ARCHITECT'S SUPPLEMENTAL INSTRUCTIONS

PROJECT:	The Reserves at South Lake New Apartment Complex Grinnell, IA	Report No.	Three (3)
OWNER:	OPG South Lake Partners, LLC Dan Maximuk 234 N. Santa Fe Ave, Suite A Salina, KS 67401	Date	January 18, 2022
CONTRACTOR:	MCP Group 3501 SW Fairlawn Rd. Topeka, KS 66614	Architect's Proj No.	20-3118
		Contract For:	General Construction Mechanical, Electrical

IFA Plan Review

1/4"=1'-0" REF. BUILDING PLANS ON SHEETS A2.10 & A2.11 FOR STANDARD LOCATIONS

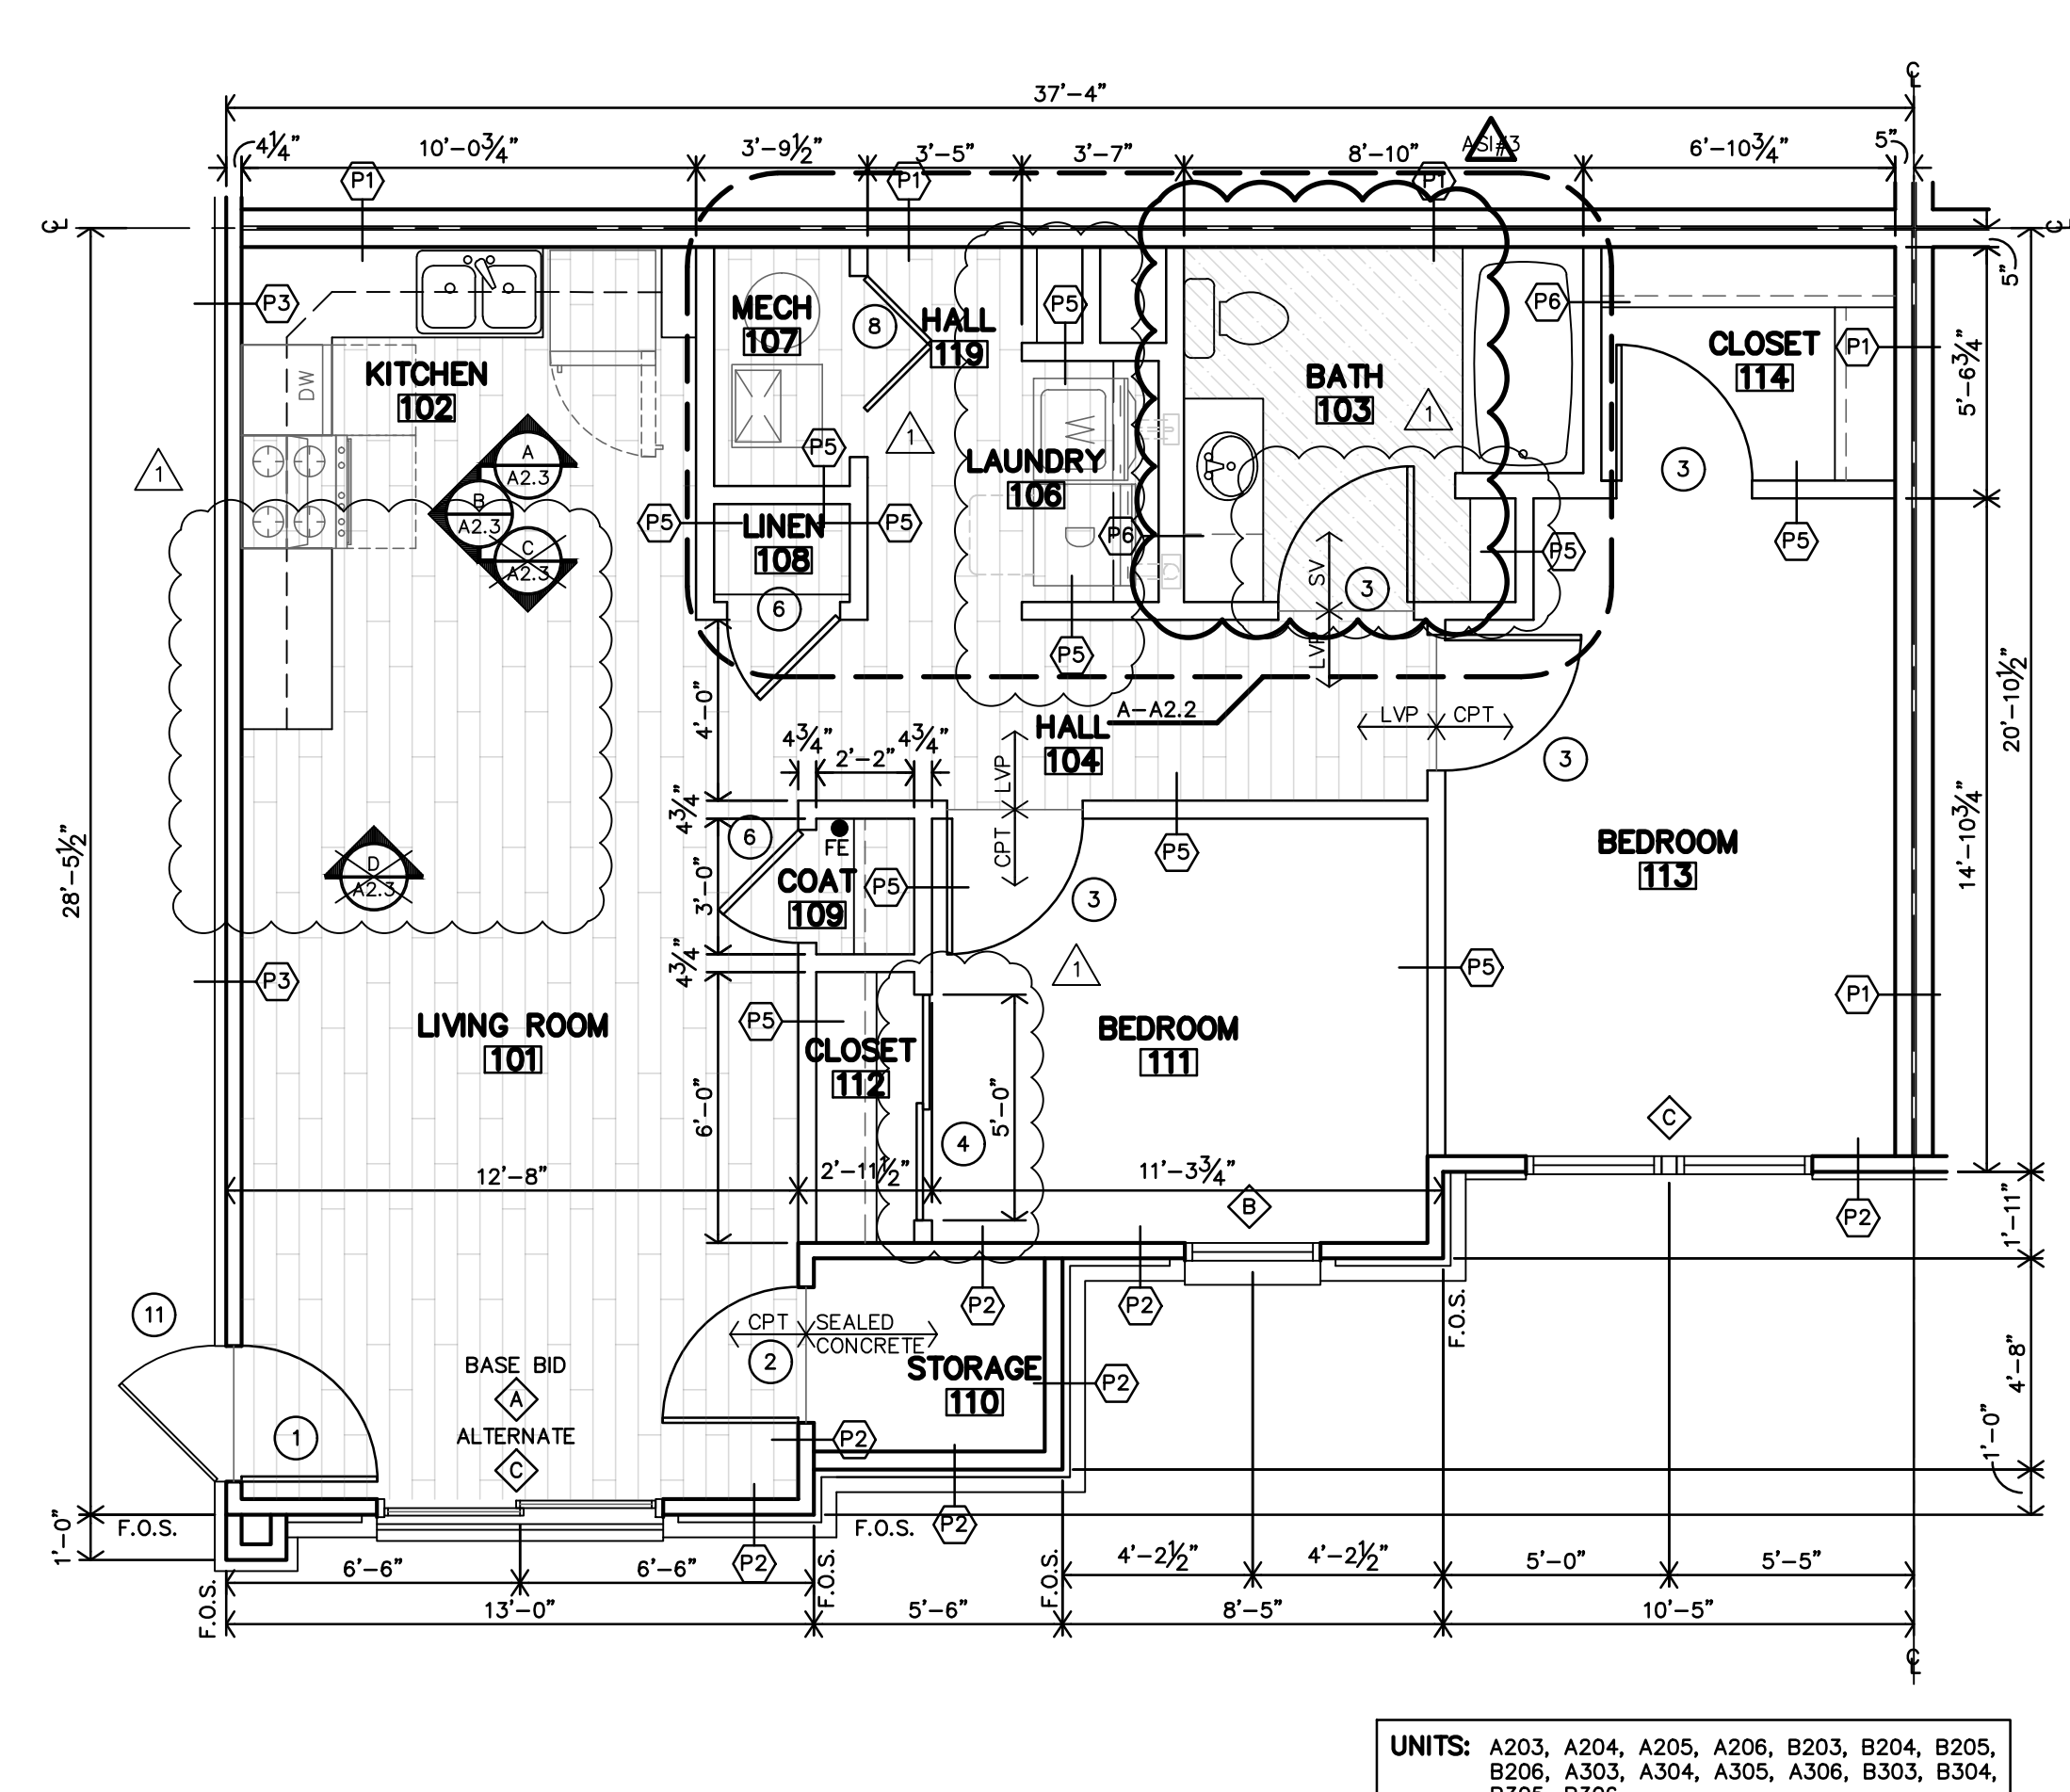
1. IFA Plan Review and Responses is attached for reference. Associated revised drawings and specifications attached and listed below
 - a. Drawings
 - i. Sheet A2.1 – Floor Plans A, B, C & D – Finished flooring material in Baths have been changed to Sheet Vinyl.

8. Bathroom floors must be a sheet vinyl product that meets QAP requirements. See G.6.3 in Part C – Threshold Requirements... Sheets A2.1, A2.2 and A2.4 have been revised to show bathrooms floors as Sheet Vinyl product. Specifications have been revised as well. Attached.

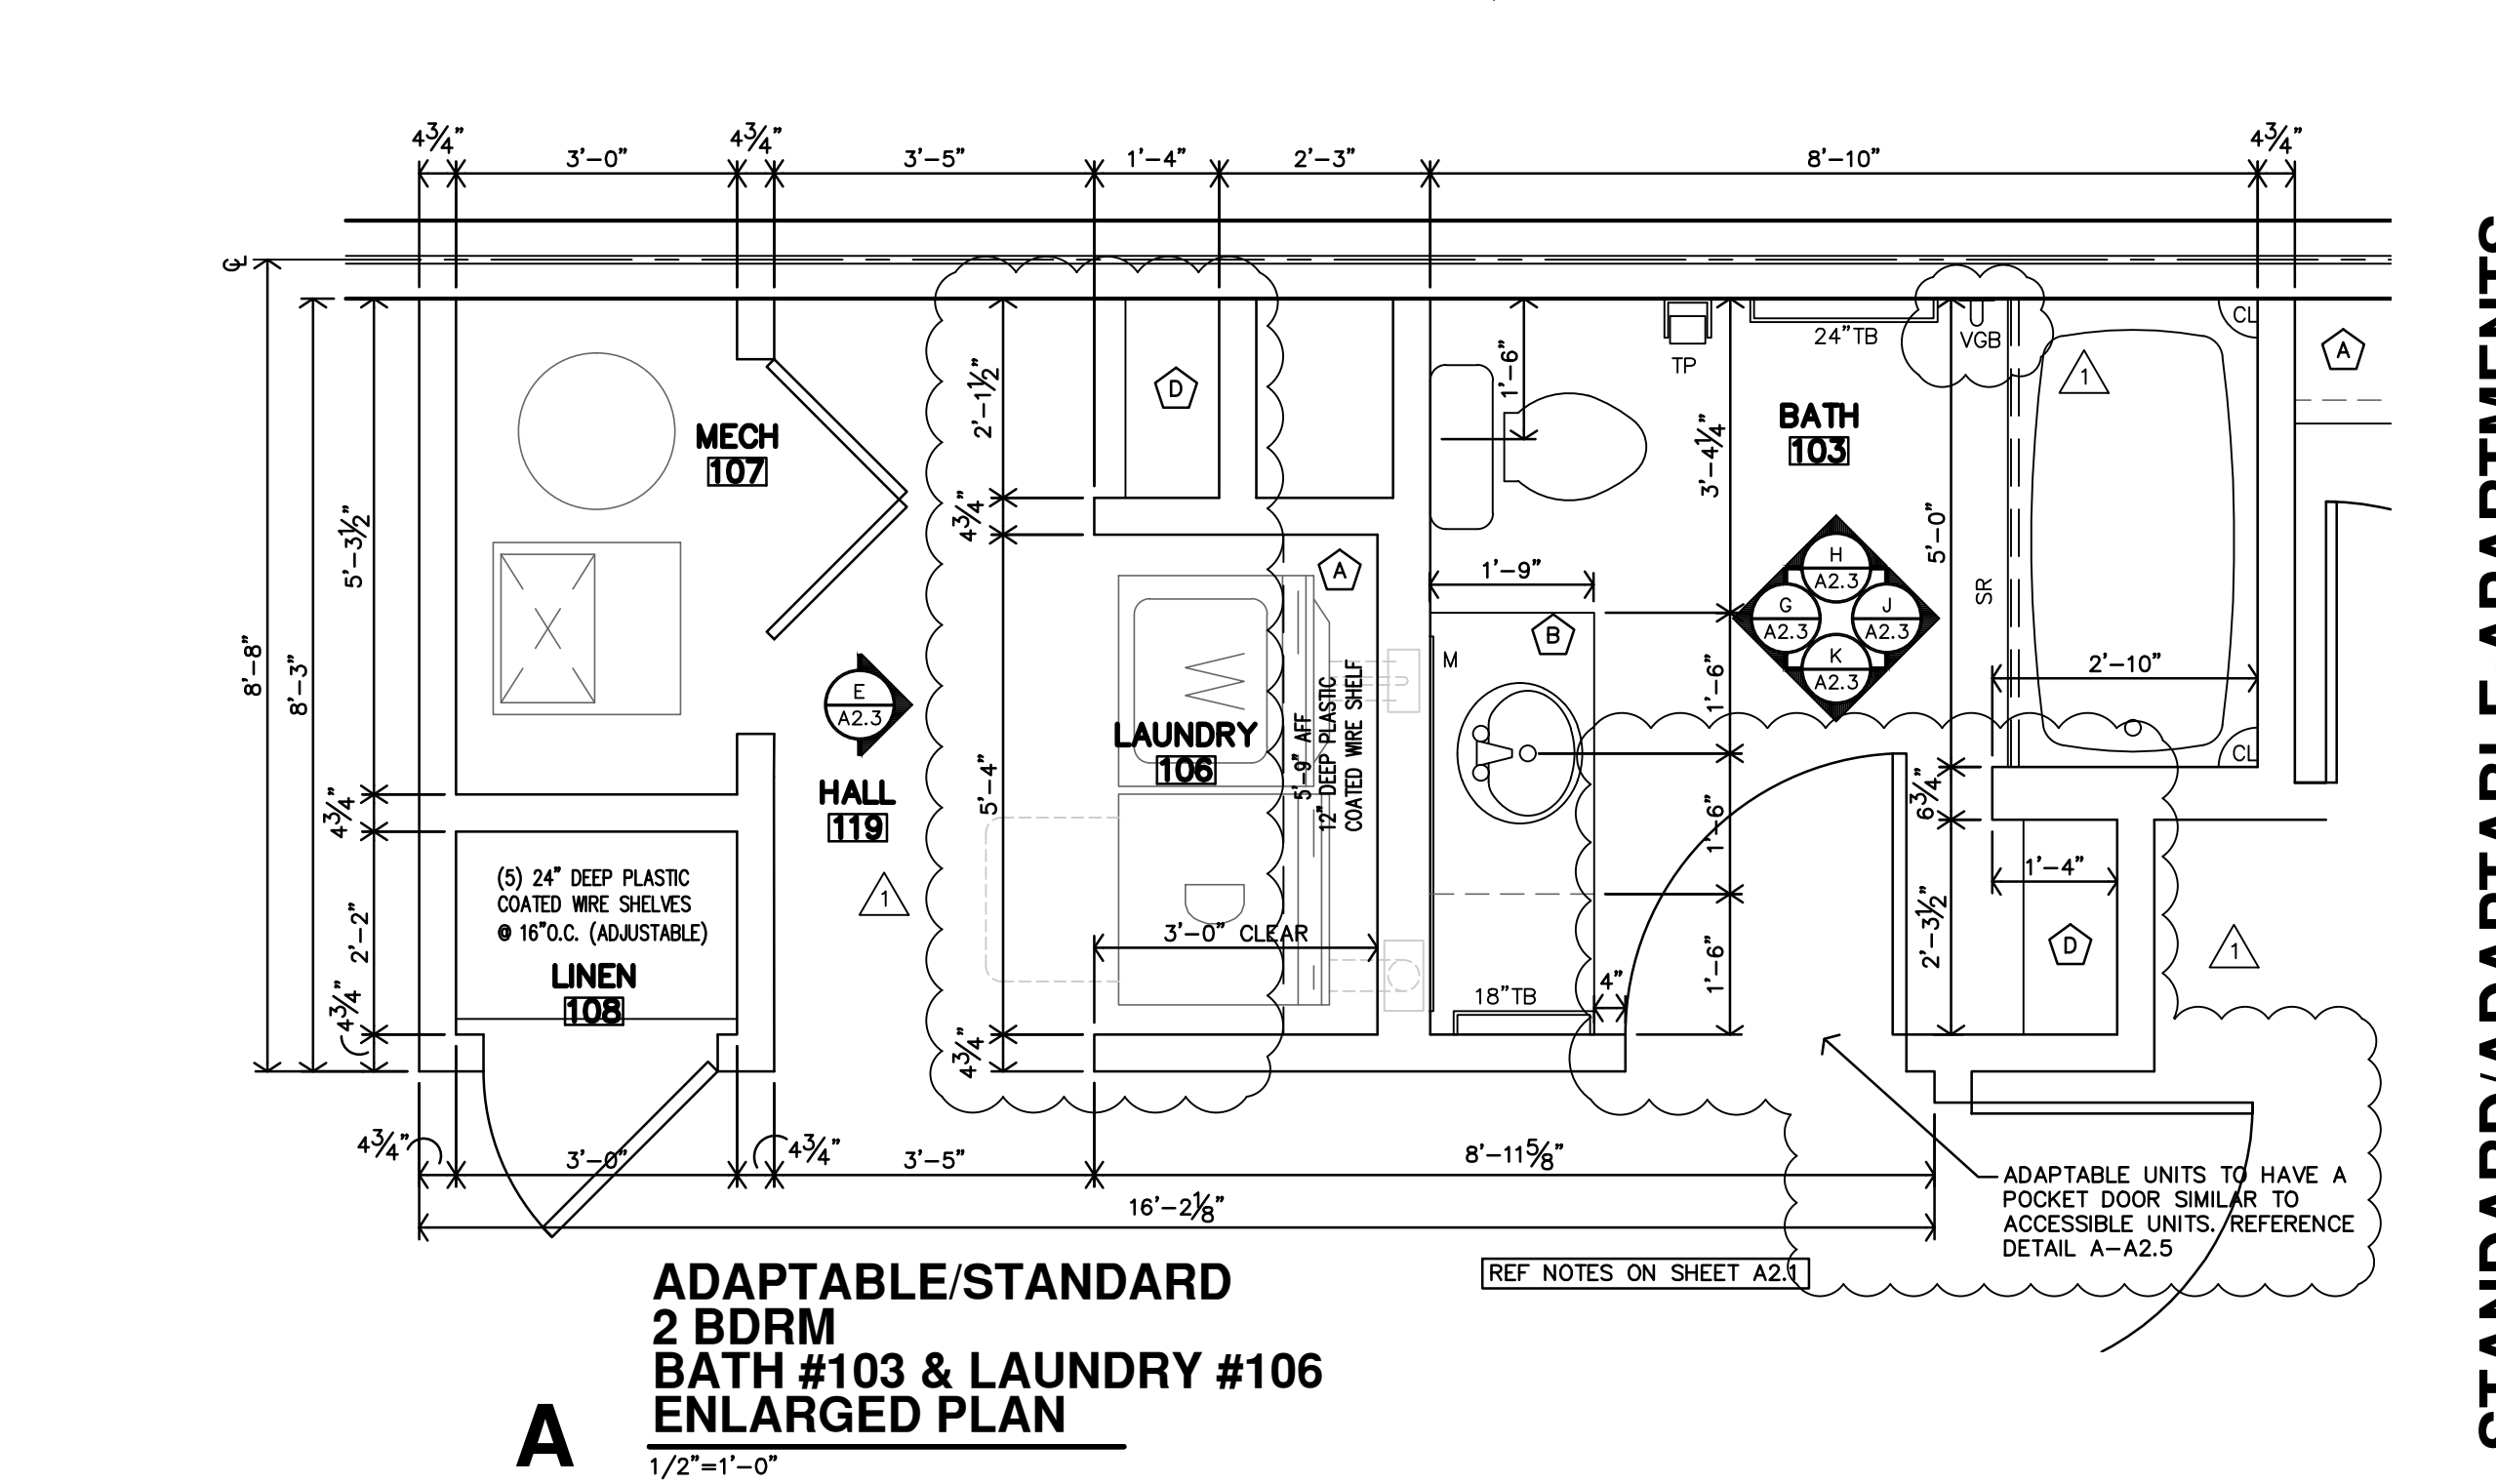
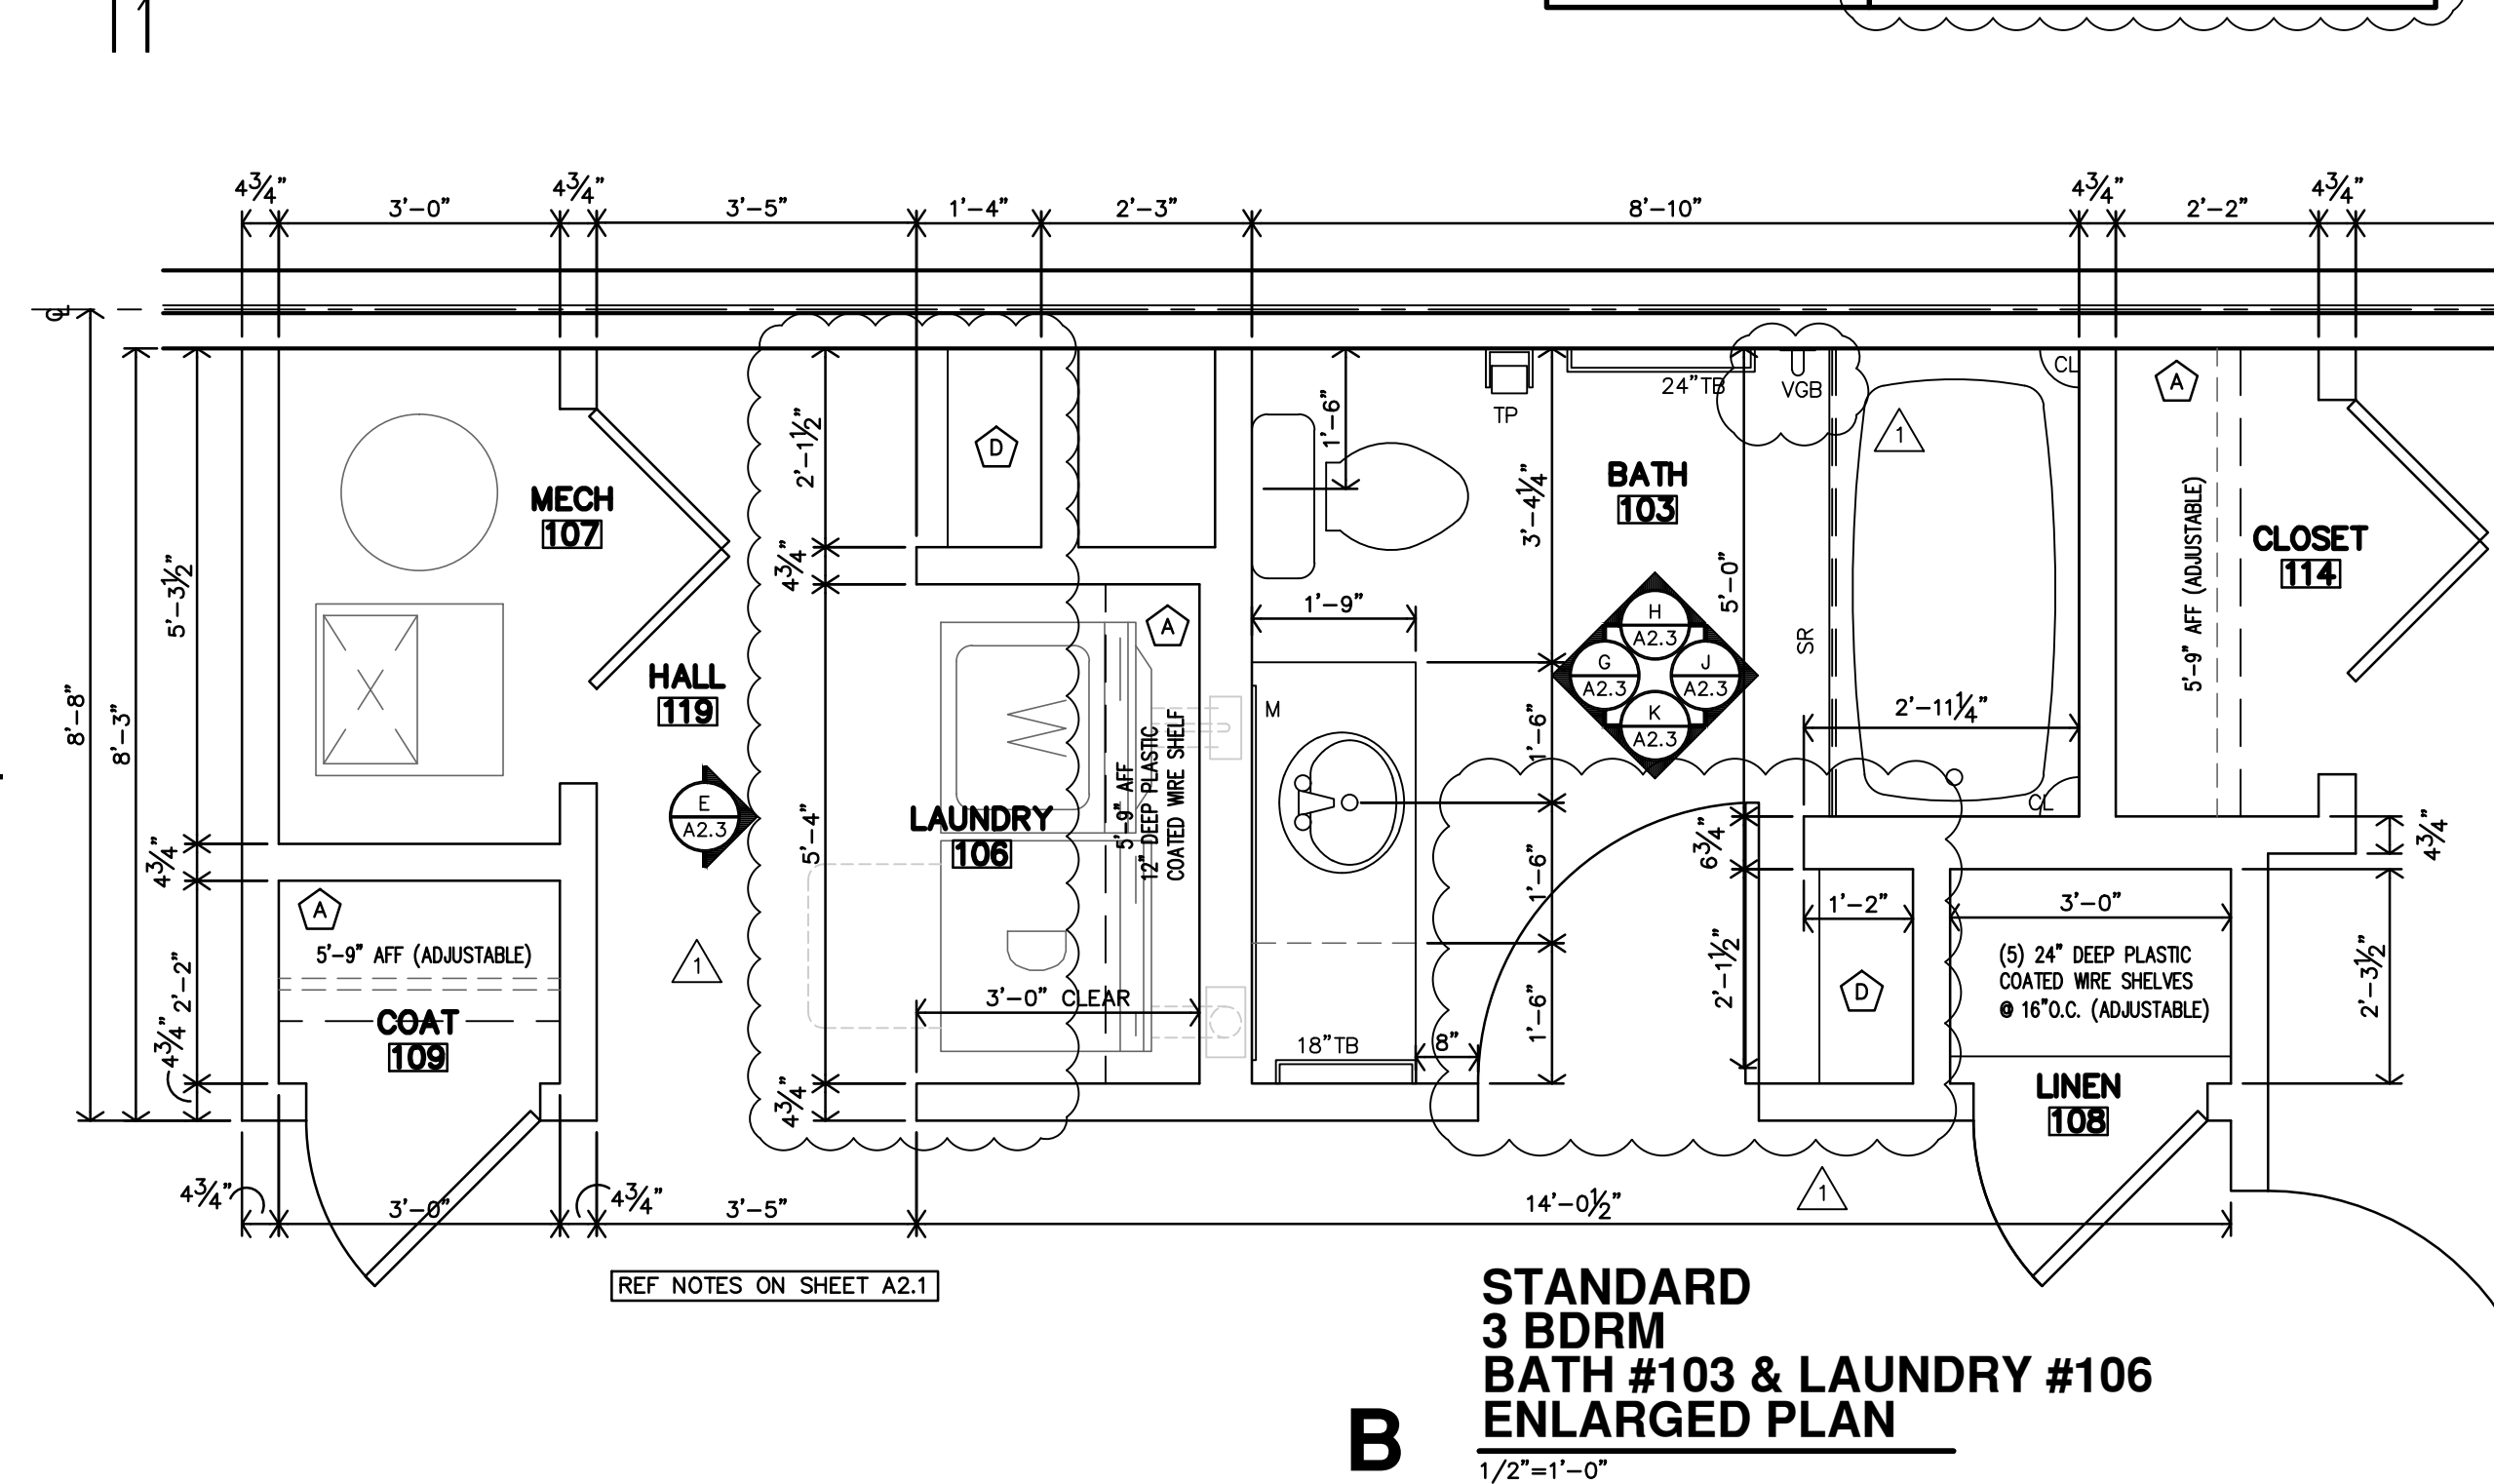
- ii. Sheet A2.2
 1. Apartment Interior Finish Schedule – Bath 103 & Master Bath 118 have been changed to Sheet Vinyl. Laundry 106 & Linen 108 have been changed to either Sheet Vinyl or Vinyl Plank (reference unit floor plans for material locations).

2. Apartment Door Schedule: Door 1 has been changed to a steel frame.
 - iii. Sheet A2.4 – Floor Plans A, B & C – Finished flooring material in Baths have been changed to Sheet Vinyl.

4. Unit entry doors must have steel frames. Schedule shows wood. The door schedule on Sheet A2.2 has been revised to show steel frames. The specifications have been revised as well. See attached.
